# Tool & Product Update

# GETTING A GRIP ON HANDLE LIFE

## A NEW SOLUTION TO THE LIFE OF YOUR PNEUDRAULIC TOOL HANDLE

July 16, 2014  
**PB620**

**Configuration of standard new handle assembly**

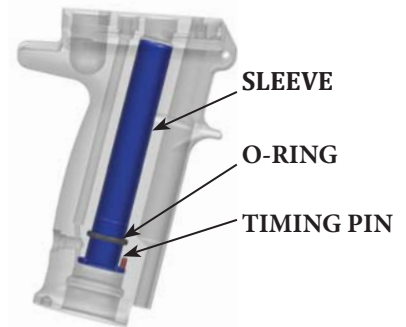
Field tested results of newly designed pneudraulic tools with sleeved handles have proven that converting your current press-fit-sleeve handle or solid aluminum handle to the new design offers higher resistance to wear and piston drift. This also provides the added benefit of a field-replaceable sleeve and O-ring to keep production flowing.

For ease of conversion, new handle assemblies are available for purchase initially. After the tool has been converted, individual components are available for replacement. Each handle assembly contains the new handle, the internal sleeve, and the O-ring.
